# CITY OF CHANHASSEN

**CASE #** 2017-10

B. “The Chanhassen Planning Commission recommends that City Council approve the Amended **Subdivision Preliminary Plat** creating 19 lots, 3 outlots and dedication of public right-of-way, as shown in plans prepared by Landform dated, May 1, 2020, subject to conditions in the staff report; and

**PROPOSAL:** Amended Preliminary Plat, Regional Mixed-Use Planned Unit Development (PUD), 118 acres of land for the establishment of a mixed-use development.

**AMENDED PRELIMINARY PLAT**

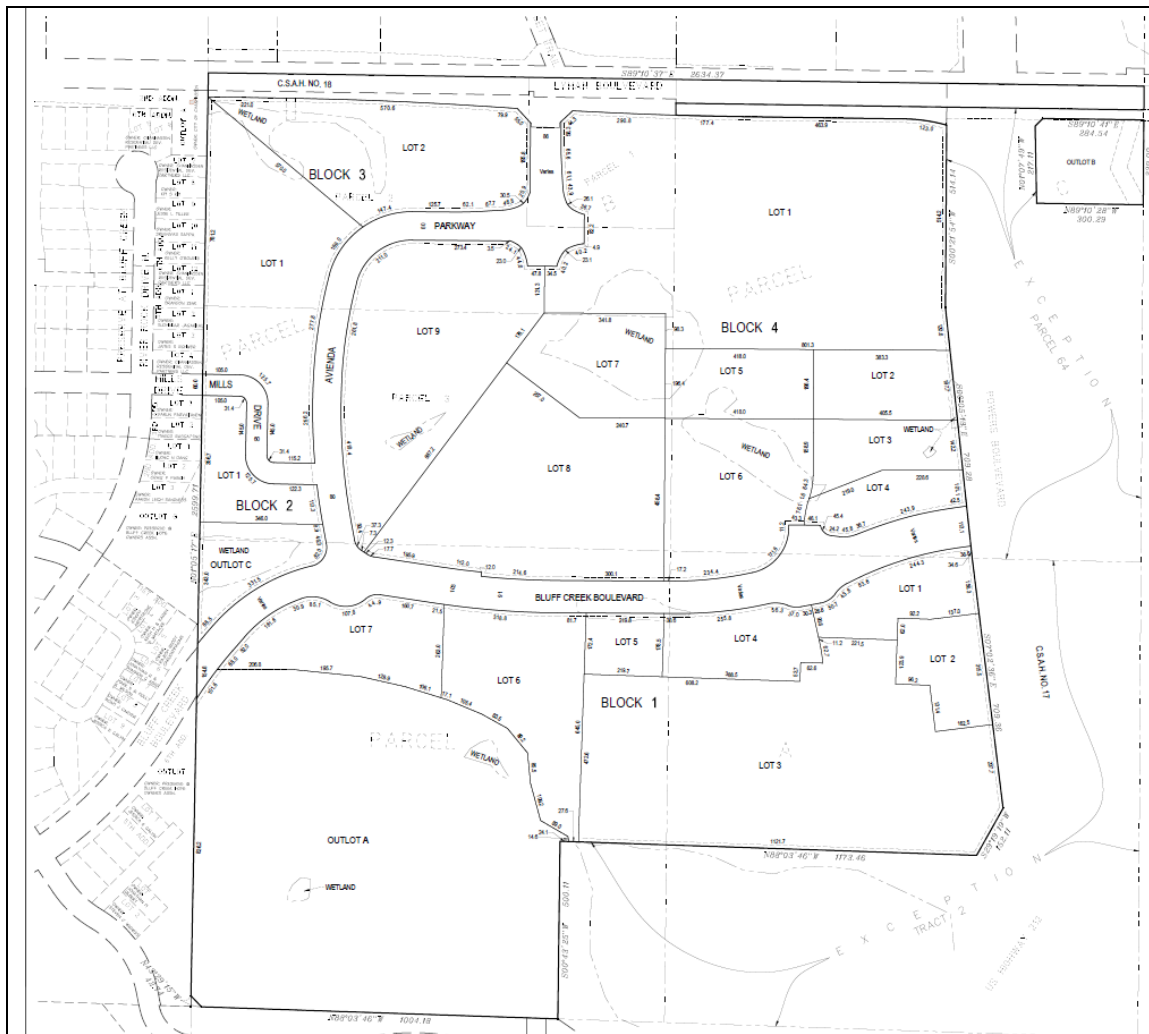
The proposed street plan is consistent with the AUAR Update, although modifications have been made to Avienda Parkway. Previously, Avienda Parkway looped around the inside of the development. The modification cut the loop in half. After review, staff finds that the required

connectivity addressed in the AUAR Update is still being met with the proposed street layout, and the modification decreases the amount of right-of-way the city would have to maintain. Bluff Creek Boulevard connects to the intersection with Powers Boulevard and the TH 212 ramp. The connection to Sunset Trail is made to the north, and the connection to The Preserve at Bluff Creek development is made by extending Mills Drive. These connections are tied together by the proposed Avienda Parkway.

Avienda Parkway is proposed to be a 36-foot wide roadway with a two-way left-turn lane. A roundabout will be constructed at the intersection with Sunset Trail. Staff recommends the applicant look at adding traffic calming measures to Avienda Parkway at Lots 1 and 2, Block 3 and Lot 9, Block 4. Specifically, the applicant shall look to incorporate pedestrian-friendly crossing features to the intersections at Mills Drive and Avienda Parkway, and where private drives intersect Avienda Parkway.

Sanitary structures along Bluff Creek Boulevard shall be moved out of the landscaped median and into the center of the eastbound travel lane for future maintenance access considerations. Further review of the final placement of the sanitary sewer main and its appurtenances will be conducted prior to final plat in order to ensure adequate easements for future maintenance activities.

Parking lot, perimeter, foundation, and open space landscaping will need to meet minimum city requirements and, ideally, exceed those requirements. As drawn on the submitted plans, the parking lot design is denoting only half as many landscape islands as would be required by ordinance. Installing only 50% of the landscaping leaves large expanses of unadorned, heat-accumulating, blank pavement. The intent of city ordinances is to eliminate vast, unaesthetic parking areas. This site is ideal for incorporating resilient landscaping that serves to create a pleasing environment, trap stormwater and reduce water use. Large planting beds that can act as stormwater features and allow for optimal tree and plant growth as well as elevated aesthetics should be incorporated. Maplewood Mall should serve as an example of parking areas that endeavor to minimize the detrimental effects of impervious surfaces. For a local example, the

5. The applicant proposes an Ultimate Plan for the Bluff Creek intersection with Powers Boulevard that includes two-lane entry into the roundabout. The city requires this Ultimate Plan be constructed at this time, but the roadway can be striped for one-lane only.

6. Staff recommends the applicant add traffic calming measures to Avienda Parkway near the residential areas of development. Specifically, the applicant shall incorporate pedestrian-friendly crossing features to the intersection at Mills Drive and Avienda Parkway.

9. Sanitary and water main structures shall not be located within landscaped medians or roundabouts. Final review of the location of sanitary sewer mains and water mains, and their appurtenances, will be conducted prior to final plat and/or permitting.

1. Parking lot islands shall be linear areas incorporating planting area and stormwater management.
2. If the applicant chooses to install the minimum requirement sizes of parking lot landscaping islands, then silva cells, engineered soil or other accommodations must be used.
3. No more than 20% of the total trees should be from any one genus and no more than 10% should be from any one species.
4. A reuse watering system should be considered to irrigate all plantings within the site.
5. Drought tolerant plants shall be incorporate into the overall landscape plan.
6. Proposed landscaping plant materials shall be selected based on site conditions.
